Urban Design Assessment Report

121-133 Burwood Road and 36 - 40 Railway Parade, Burwood, NSW 2134

Date: 16 December 2014

Figure 3: Extract of Lower Ground retail (source DR Architects)

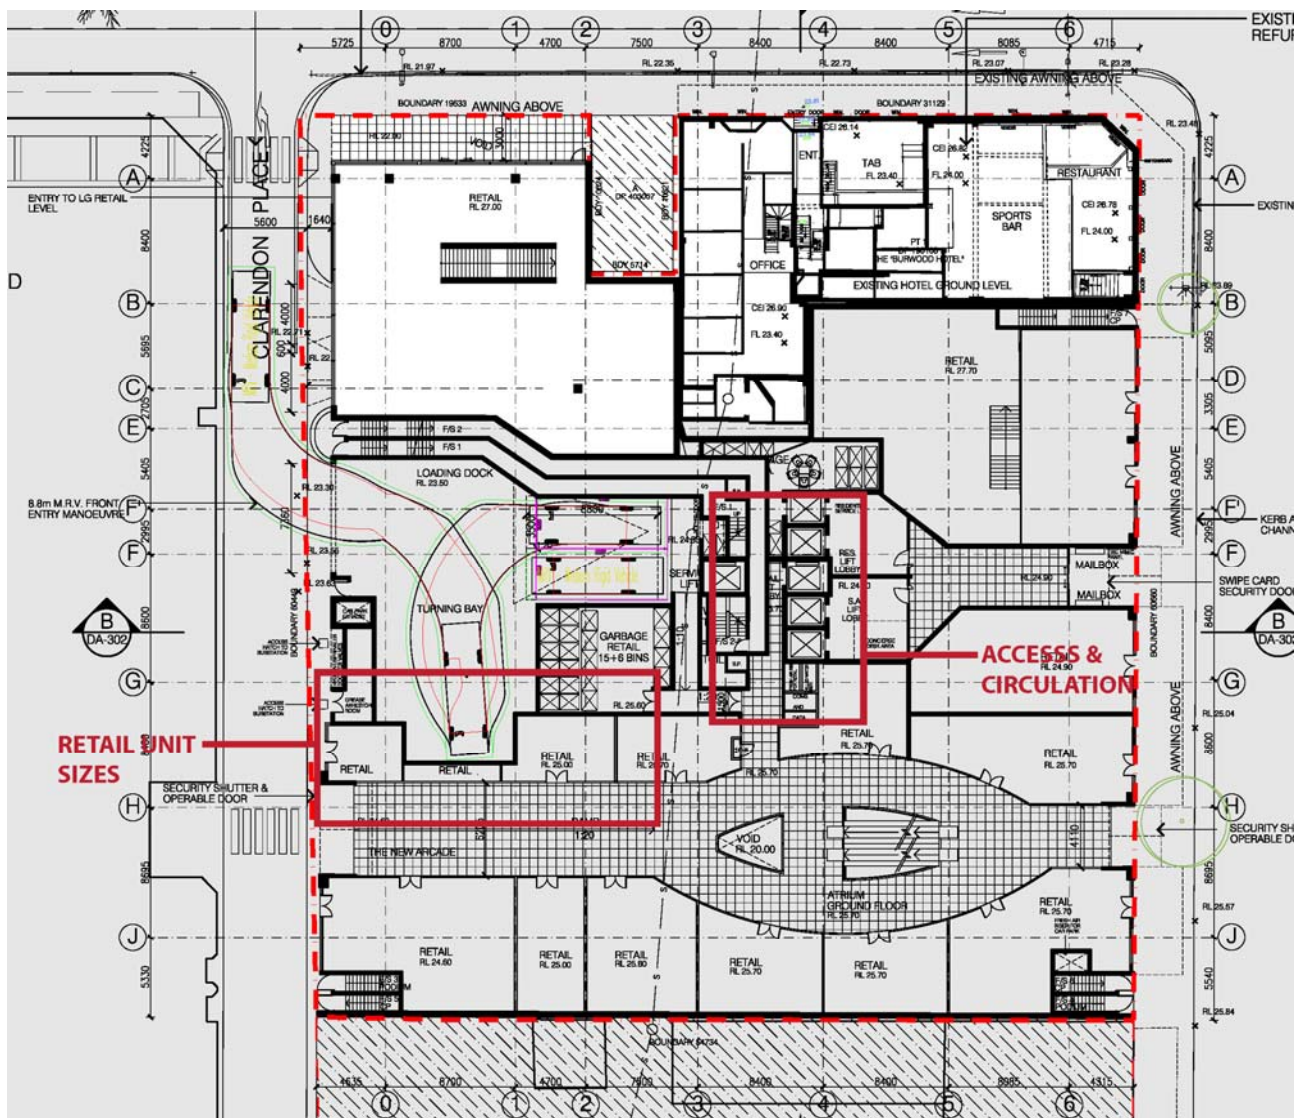
The layout of the retail component is generally considered poor and unresolved. There are a number of very small units, where the useability of the space is questioned. A number of units, particularly within the centre of the podium footprint, will not receive any natural daylight. The circulation outside the lift on the Mezzanine level does not work and is unacceptable (see Figure 3). The retail garbage store is located on this level, and access via lift for retail units on other levels will not work with a corridor of insufficient width.

In addition to this, GMU considers that the location of some of the retail uses and the restaurants should be reviewed. The location of retail uses overlooking Burwood Road on Retail Level 1 is likely to result in no activation to the street. Similarly, as the restaurant spaces are located up on Retail Level 2, with their proposed setback, they are completely disconnected from the street. GMU believes that the restaurant which is located to the west side (Clarendon Road side) should be relocated to the Burwood Road edge of Retail Level 1. In place of this restaurant on the retail level 2, a gym/fitness centre could be appropriate, which could be used by residents of both the apartments and serviced apartments. A space such as this located here, for use by occupants of the building would then have a better relationship with the proposed common open space for residents.
